- SUMMARY OF CHANGES BETWEEN CONSENTED PLANNING DRAWINGS, AS PER APPLICATION REF 132952/J0/2022 AND PROPOSED SECTION 73 APPLICATION DRAWINGS:**
- 1 - WIND MITIGATION**
WIND MITIGATION SCHEME AMENDED.

Drawing Number	Revision																																																																																		
6555-P-B500-P-00	J

Drawing Status	PLANNING

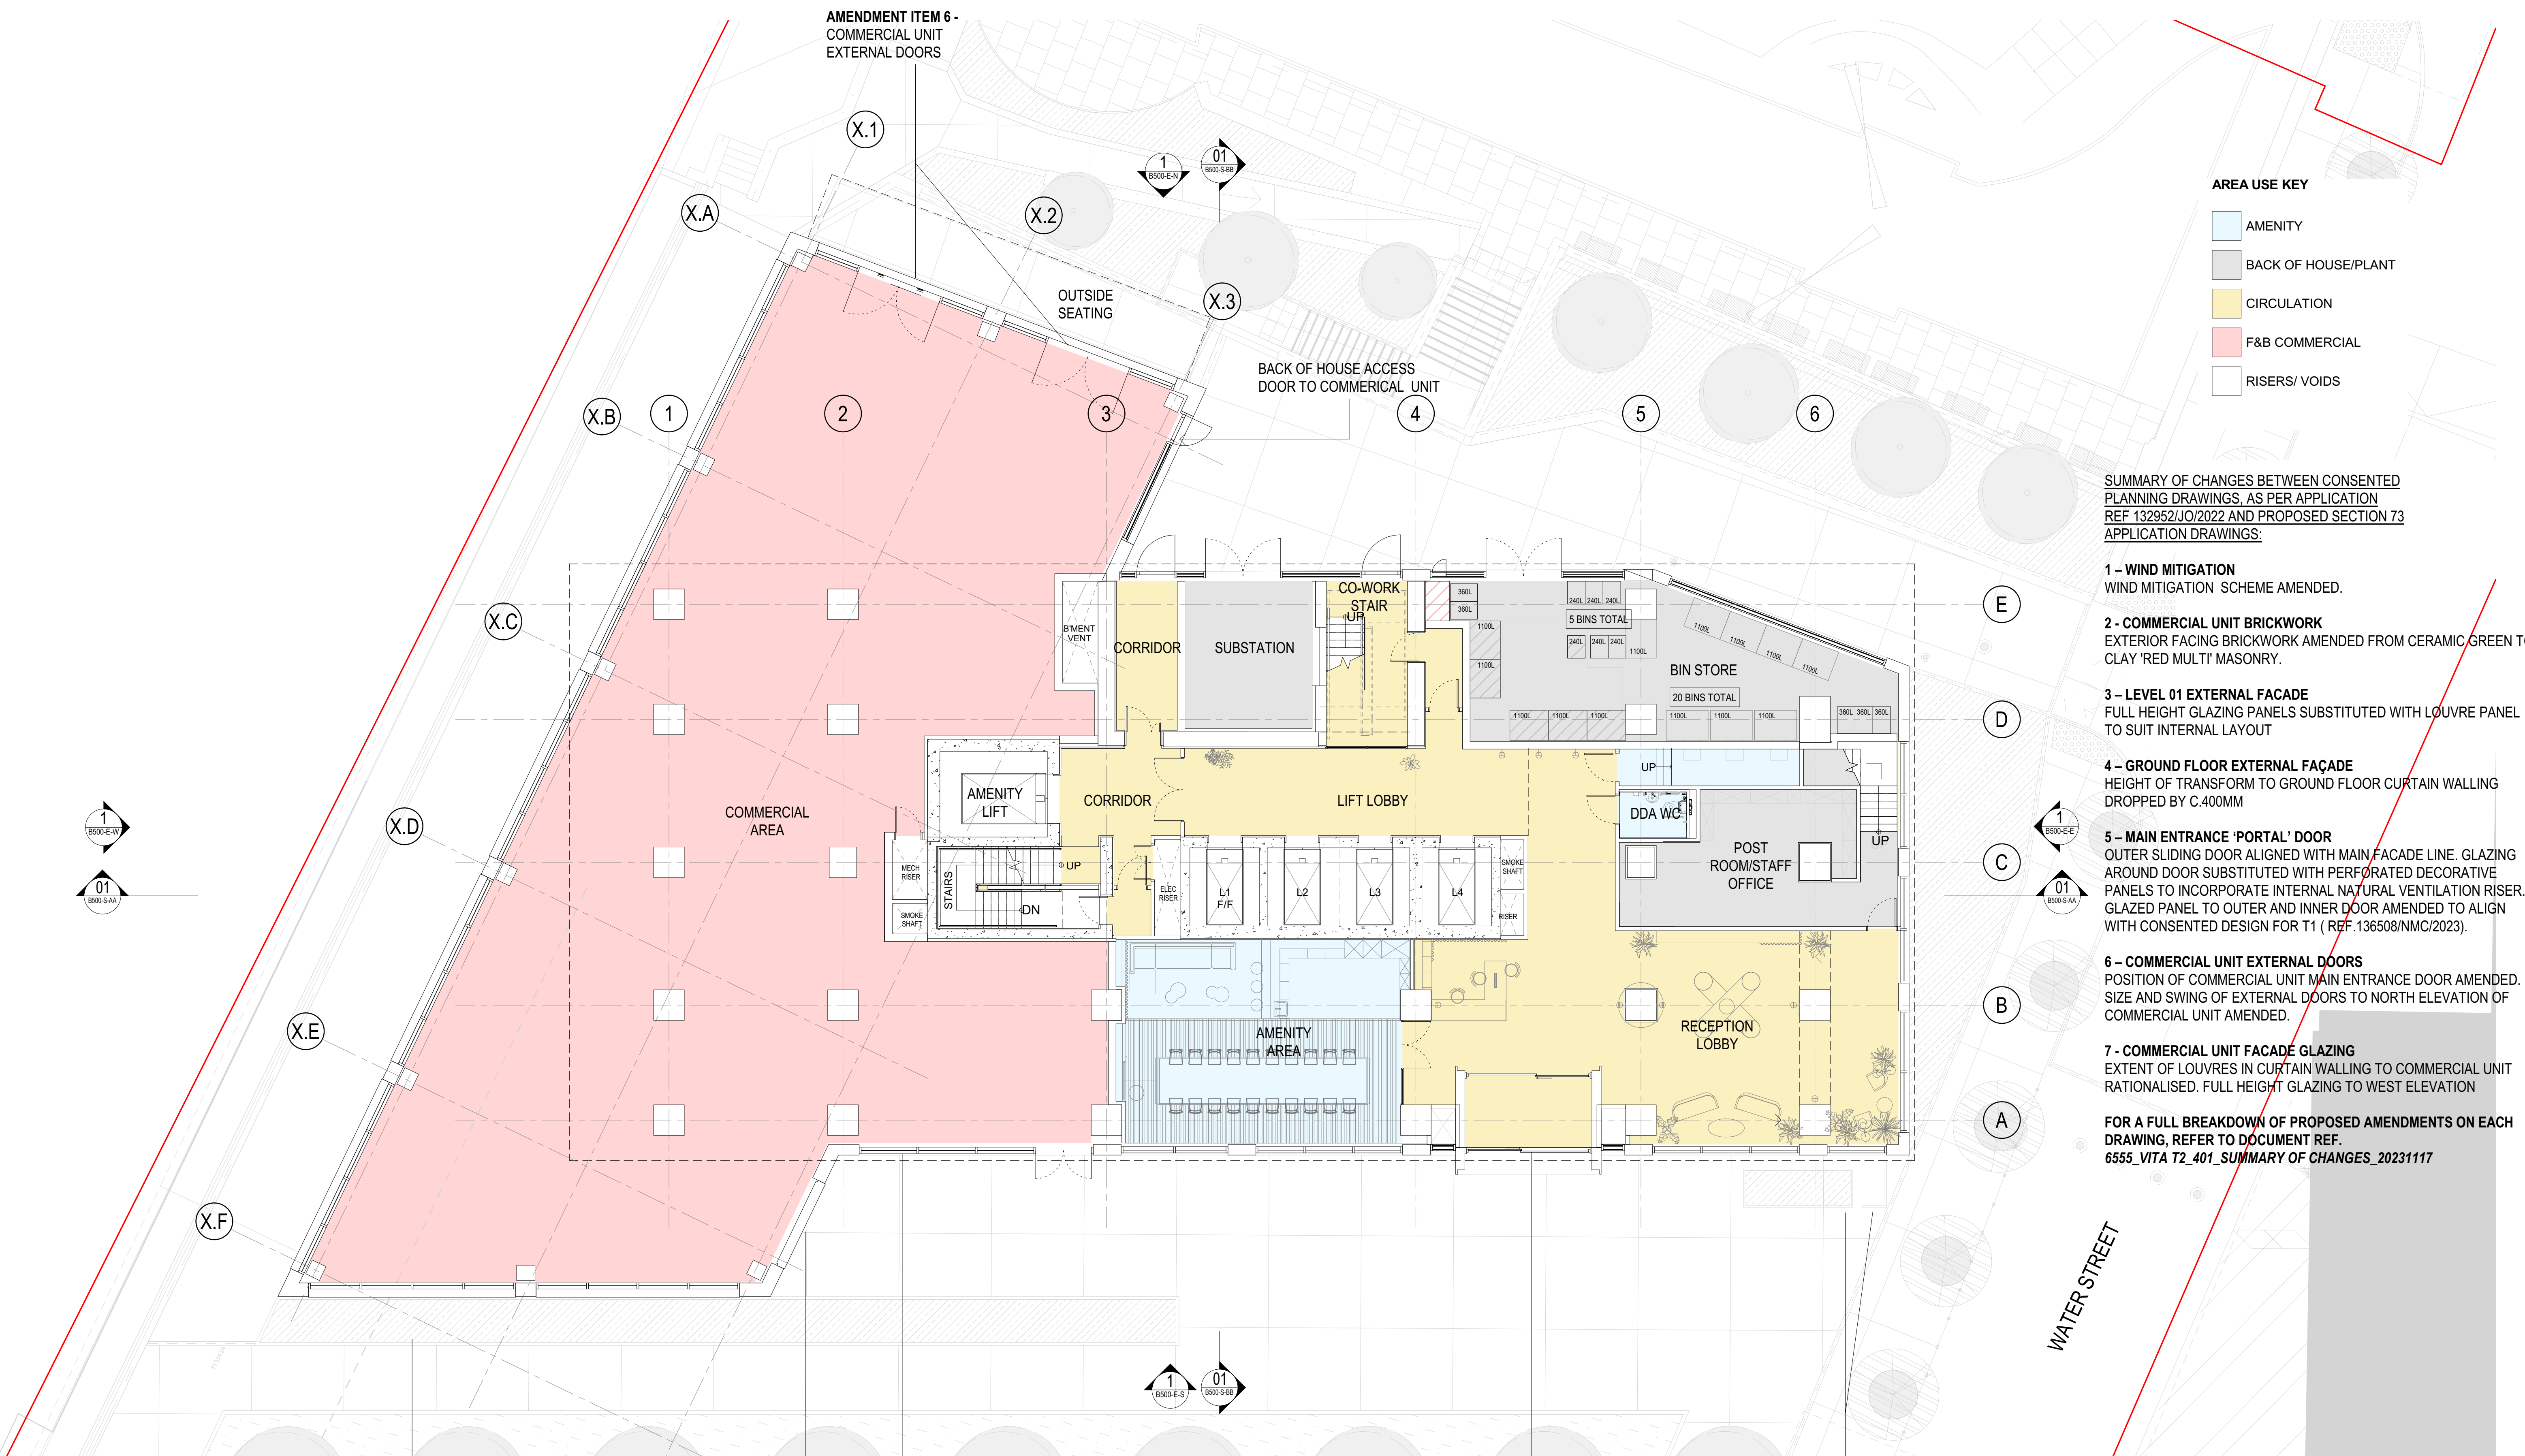
- 2 - COMMERCIAL UNIT BRICKWORK**
EXTERIOR FACING BRICKWORK AMENDED FROM CERAMIC GREEN TO CLAY 'RED MULTI' MASONRY.
 - 3 - LEVEL 01 EXTERNAL FACADE**
FULL HEIGHT GLAZING PANELS SUBSTITUTED WITH LOUVRE PANEL TO SUIT INTERNAL LAYOUT

- 4 - GROUND FLOOR EXTERNAL FAÇADE**
HEIGHT OF TRANSFORM TO GROUND FLOOR CURTAIN WALLING DROPPED BY C.400MM
 - 5 - MAIN ENTRANCE 'PORTAL' DOOR**
OUTER SLIDING DOOR ALIGNED WITH MAIN FACADE LINE. GLAZING AROUND DOOR SUBSTITUTED WITH PERFORATED DECORATIVE PANELS TO INCORPORATE INTERNAL NATURAL VENTILATION RISER. GLAZED PANEL TO OUTER AND INNER DOOR AMENDED TO ALIGN WITH CONSENTED DESIGN FOR T1 (REF.136508/NMC/2023).

- 6 - COMMERCIAL UNIT EXTERNAL DOORS**
POSITION OF COMMERCIAL UNIT MAIN ENTRANCE DOOR AMENDED. SIZE AND SWING OF EXTERNAL DOORS TO NORTH ELEVATION OF COMMERCIAL UNIT AMENDED.

- 7 - COMMERCIAL UNIT FACADE GLAZING**
EXTENT OF LOUVRES IN CURTAIN WALLING TO COMMERCIAL UNIT RATIONALISED. FULL HEIGHT GLAZING TO WEST ELEVATION
- FOR A FULL BREAKDOWN OF PROPOSED AMENDMENTS ON EACH DRAWING, REFER TO DOCUMENT REF. 6555_VITA T2_401_SUMMARY OF CHANGES_20231117**

- AMENDMENT ITEM 1 - WIND MITIGATION
- AMENDMENT ITEM 6 - COMMERCIAL UNIT EXTERNAL DOORS
- AMENDMENT ITEM 4 - GROUND FLOOR EXTERNAL FACADE
- AMENDMENT ITEM 5 - MAIN ENTRANCE 'PORTAL' DOOR
- AMENDMENT ITEM 1 - WIND MITIGATION
